Machine	TASKI swift 35, Foam Generator
Subassembly	Tank

Magnetic valve with new coil and external rectifier

GTS Newsletter

2014/04E

New coil of higher value

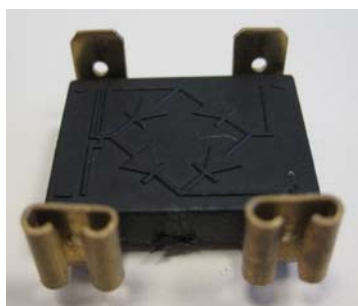
Coil:

A supplier who is able to deliver a coil of the needed quality has been found. In addition has the insulation class of the coil been increased from class F (155°C) to class H (180°C).
